Senior Policy Officer (Management Planning) Environment ACT PO Box 144 LYNEHAM ACT 2602

COMMENTS FROM MARK BUTZ ON CLEAN WATER, HEALTHY LANDSCAPE: LOWER COTTER CATCHMENT DRAFT STRATEGIC MANAGEMENT PLAN

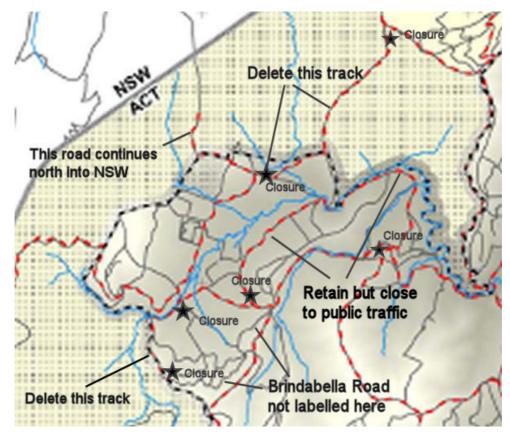
In the Blundells Flat-Shannons Flat area, most of the proposed retention of roads is supported. However, comments below oppose retention of some and suggest retention of others without open public access. To clarify these comments, an annotated extract of Map 7 is included.

I am strongly opposed to retention of a track down the south face of Mount Blundell within Namadgi NP (and part of an area listed on the Register of the National Estate).

This track is steep for most of its length, and particularly steep into Coree Creek, representing a risk to both emergency vehicles carrying water and to water quality in that creek from recreational use in a moist shady location with very high erodibility. In its higher parts the track is visually obtrusive and detracts from an area which includes tall *E. fastigata* forest.

Recent renewal of this route (which had largely fallen into disuse and disappeared from maps for those very reasons) has served to create expectation of access from recreational drivers/riders. Images and text have recently been placed on the Web showing four-wheel-drive vehicles negotiating this track with difficulty and having fun in the process. The locality has been named and is now a drawcard for recreational drivers seeking a challenge. Without making assumptions about driver capability, if a recreational vehicle has such difficulty, there seems little merit in retaining such a track for fire vehicles carrying water.

Retention of this track seems superfluous to fire management, given that it falls between the Pabral Road and Blue Range Road. It can only serve to encourage inappropriate vehicle use and unwarranted potential for sediment input into Coree and Condor Creeks.

Similarly, retention of the now renewed link to Pabral Road, although not as steep, is likewise not warranted in terms of dubious contribution to fire management and likely impact on catchment values from inappropriate access. In its eastern parts it too is a shady and moist area, and significant mud wallows and track widening are evident and expanding. This track too is now featured on the Web with images of four-wheel-drivers wallowing.

It may be quite justifiable to reopen these routes in the event of an emergency (after which they could be closed and rehabilitated). However, in the interests of water quality they should not be retained and maintained on a continuing basis.

The roads openly accessible to vehicles should be confined to Curries Road and Pabral Road.

Others might be retained but closed to traffic, with controlled access for management or emergency vehicles only. This restriction should apply particularly to:

- the track from Blundells which follows Condor Creek to Wombat Creek and Shannons Flat, looping back to the Brindabella Road in several places; and
- the track from Curries Road along Condor Creek above the Blundells wetland and forming the boundary of Namadgi NP in its rise to the pronounced hairpin bend on the Brindabella Road.
